RFI #: 86
Date: 3/26/2012
Job: EB-02 Keller Springs Lofts
Phone: 877-777-5115

Subject: Structural Steel dimensions

RFI #: 93
Date: 3/27/2012
Job: EB-02 Keller Springs Lofts
Phone: 877-777-5115

Subject: Steel Columns/ 2 HR Wall at Club

Drawing: Details sent on 5/15/12 Spec Section:
Cost Impact: None Schedule Impact: None

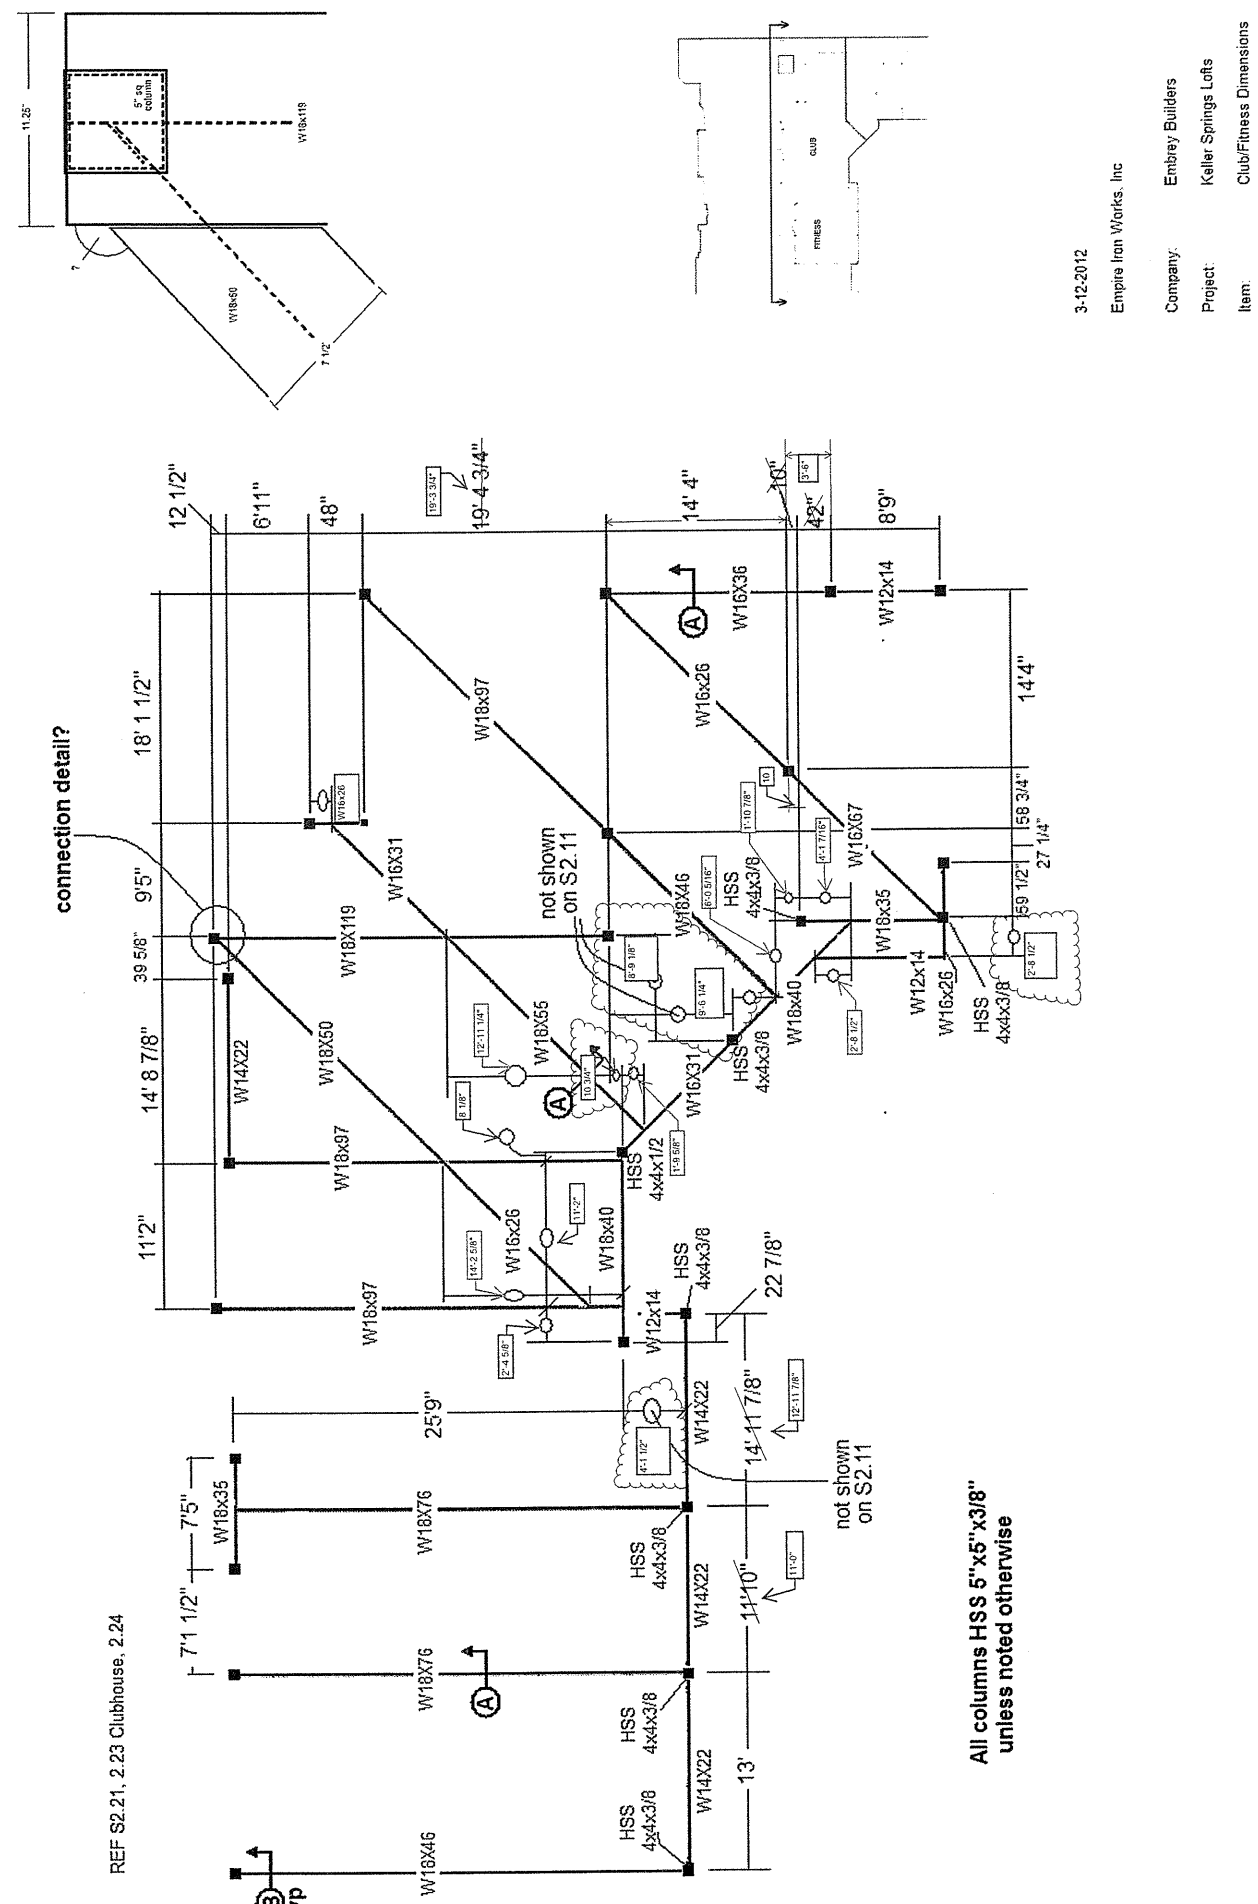
Request: **Date Required:** 6/15/2012
 One of the additional angles called for in the "Additional Angle Schedule" calls for a L6x4x7/8 LLH piece. My steel sub can't get this size but can get L6x6x3/4. Can we use that size angle for these areas?

Response:
 Please use specified size, or equivalent bent plate member.
